LOT 5-08, PH5, PE003, SKETCH
Purchaser: Habib Zamani (Jun 15, 2022 11:50 EDT)

LOT 5-08, PH5 KITCHEN LAYOUT CHANGE AND EXTENSION

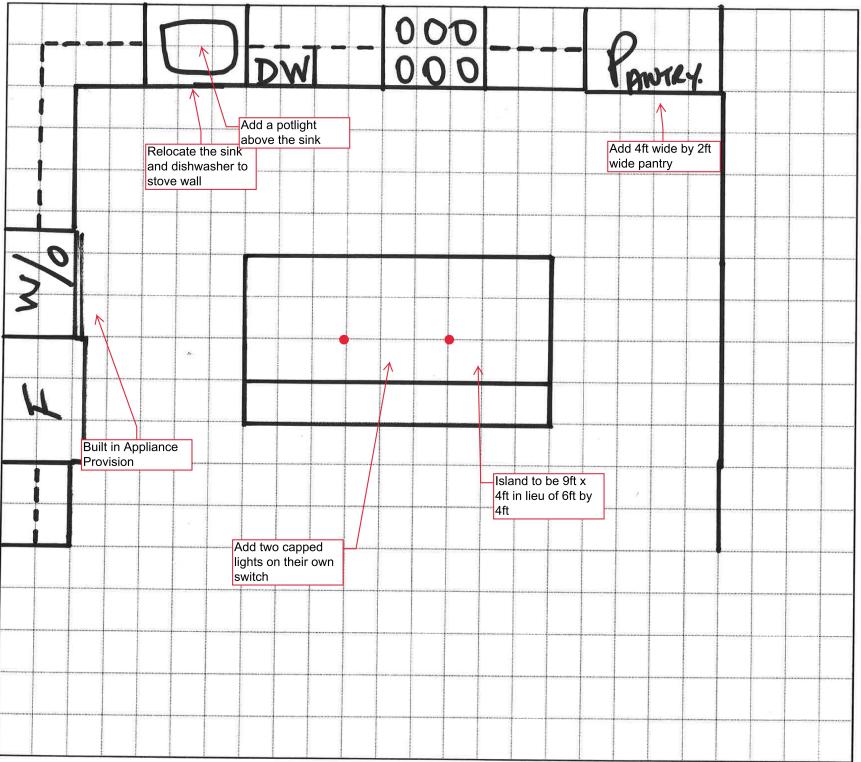
Decrease width of laundry room, provide for stackable Washer/Dryer -Increase the width of walk in closet

1. BUILT-IN APPLIANCE PROVISION - Includes Counter Depth Fridge Enclosure; Wall Oven(s) and/or Micro cabinet; 36" cooktop with pot and pan drawer

- 2. Relocate the sink and dishwasher from the island to the stove wall. No cabinets above the sink.
- 3. Add potlight above the sink
- 4. Extend kitchen cabinetry on stove all, approximately 6ft of upper and lowers.
- 5. Install a pantry 4ft wide by 2ft deep
- Increase island to 9ft wide by 4ft in lieu of 6x4 - includes the extended flat bar top

capped ceiling lights above island
